Errata – Support Craft at Liquefied Gas Facilities - Principles of Emergency Response and Protection – Onshore (2015)

Annex E – Fire and Gas Dispersion Modelling

Figure E1: Pool fire analysis of methane showing thermal heat flux

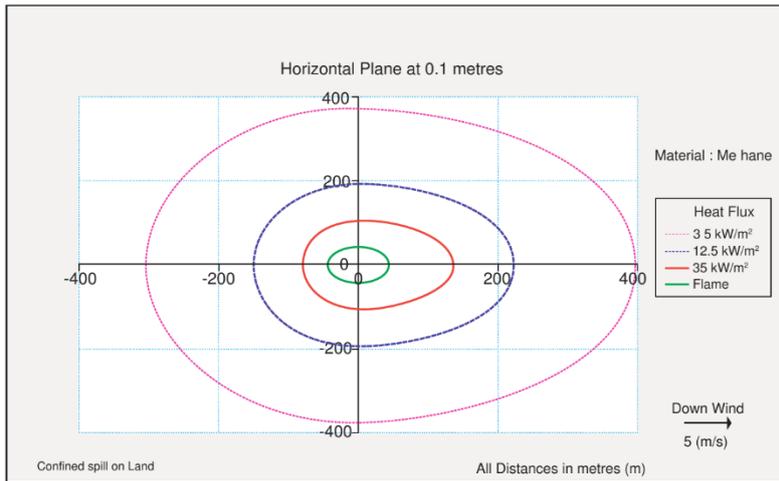
‘Material: Me hane’ should read as ‘Material: Methane’

The first value under ‘Heat Flux’, ‘3.5 kW/m²’ should read as ‘3.5 kW/m²’

Figure E2: Jet fire analysis of methane showing thermal heat flux

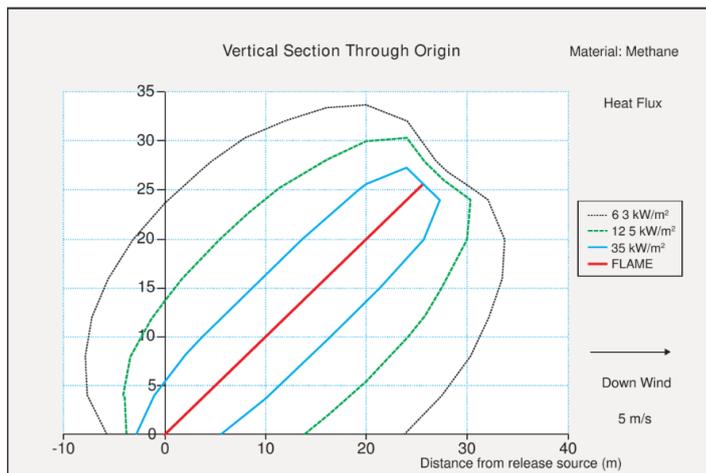
‘63 kW/m²’ should read as ‘6.3 kW/m²’

‘12.5 kW/m²’ should read as ‘12.5 kW/m²’
